Subject: Technical Review of Groundwater Modeling in Support of Idaho Water Company Water Right Transfer #73811

**February 18, 2010, IDWR Memo
from A. Wylie to C. Tesch**

Date: 18 February 2010
To: Craig Tesch
From: Allan Wylie *AW*
cc: Rick Raymondi, Sean Vincent
Subject: Review of Shekinah Model

Figure 3. Spring 2000 water level contours for the Mountain Home groundwater monitoring network (Harrington, 2001).

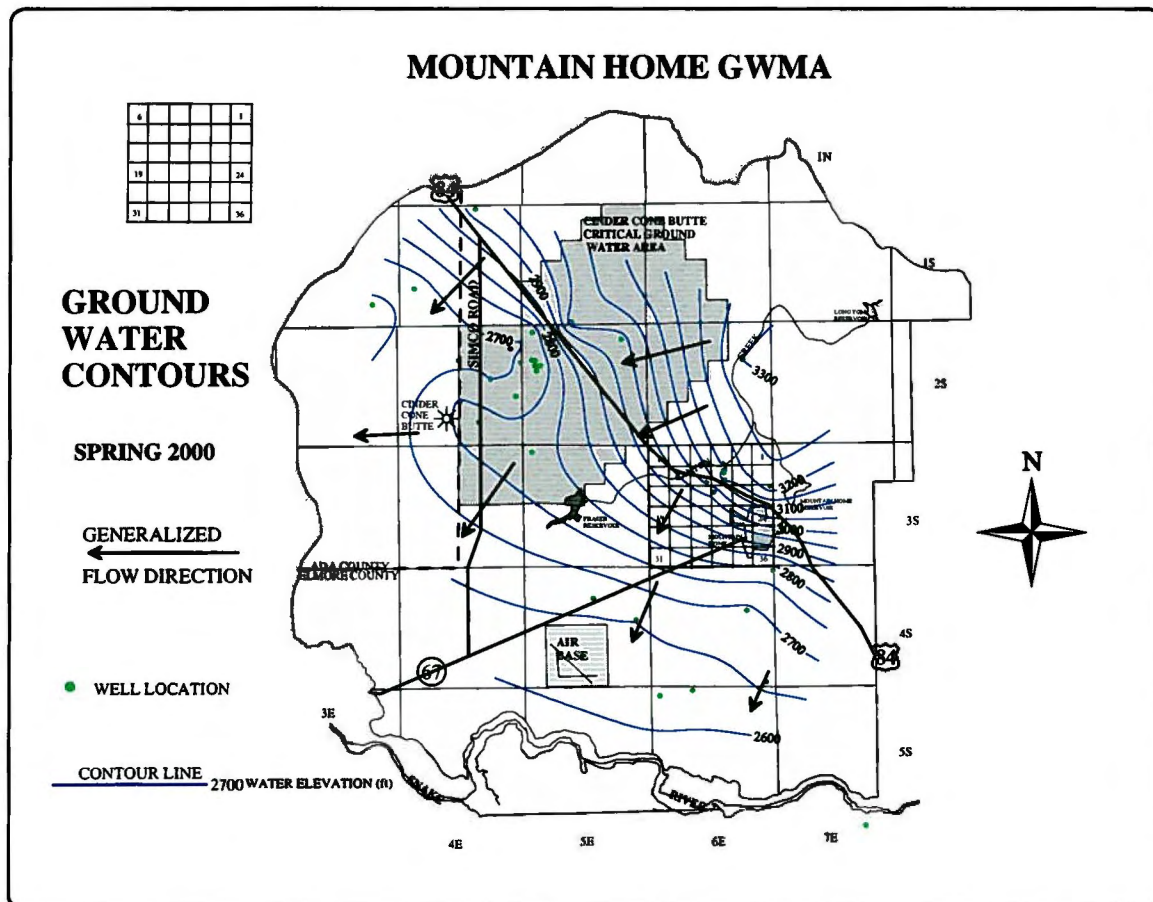
It is unclear why contours were used for calibration instead of the water levels from which they were developed. More commonly, groundwater models are calibrated to

actual water levels and goodness of fit is calculated by comparing simulated heads to measured water levels. The statement in the modeling report that “no current published groundwater contours were available for the region” (Powell, 2009, p. 23) does not explain the rationale for deciding to not use recent water level data for model calibration. In fact, a groundwater contour map could have been created from the 2000 water level data (see Figure 3) or from the 2009 data.

Figure 4. Groundwater level change from spring 1983 to spring 2009 within the IDWR Mountain Home monitoring network.

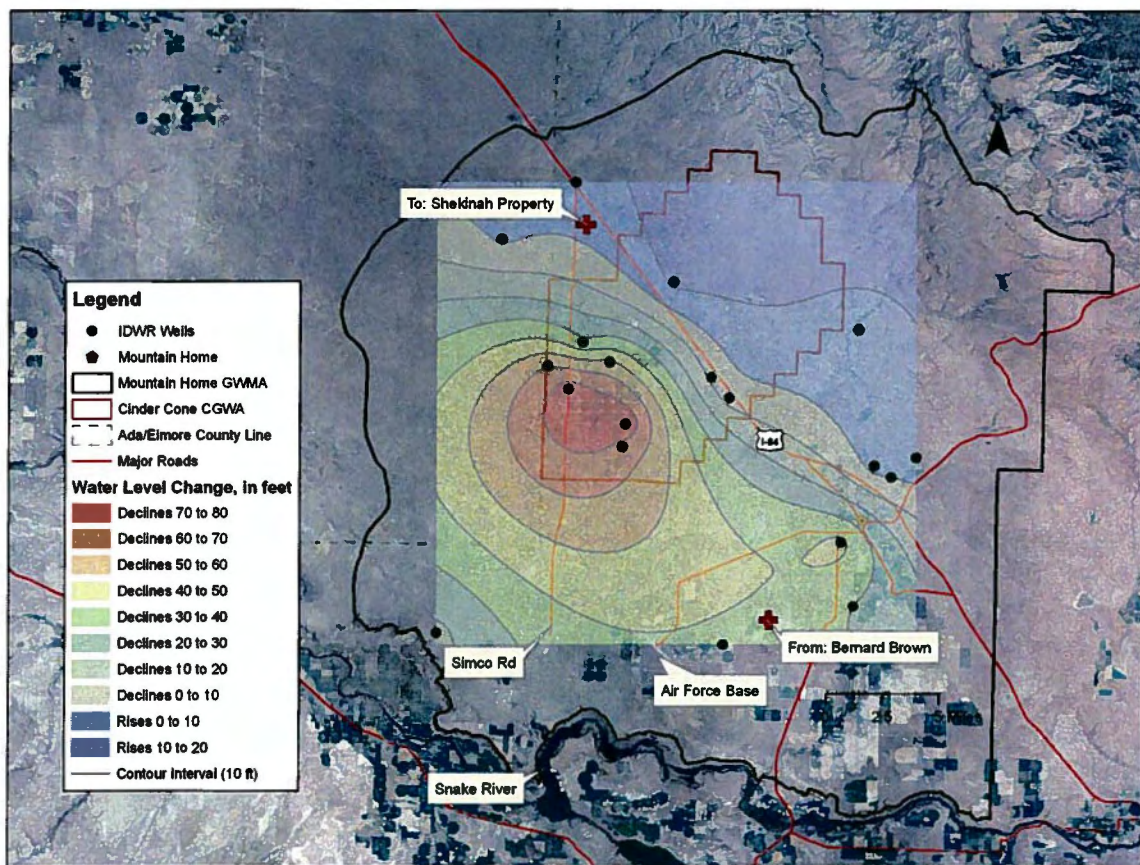
Five of the six wells in which water level increases were observed are located northeast of interstate I-84. The current PODs are located in an area with declines of 30 to 40 ft over the last 26 years, while the proposed PODs are in an area in which the water level

has risen from 0 to 10 ft. The cause of differing trends is currently unknown; there is significant uncertainty about aquifer behavior in this area due to a general lack of hydrogeologic data.

Large differences in groundwater level trends exist between the locations of the current and proposed POU (Figure 4). As Brockway Engineering states, “The groundwater elevations near the northwest portion of the Cinder Cone Butte Critical Groundwater Area have been experiencing a slight increase in elevation over the last few years, while the area near the southeastern portion of the critical groundwater area have seen steady declines” (Powell, 2009, p. 25). The extent to which stable or increasing trends in the vicinity of the proposed PODs could offset any pumping effects is unknown.
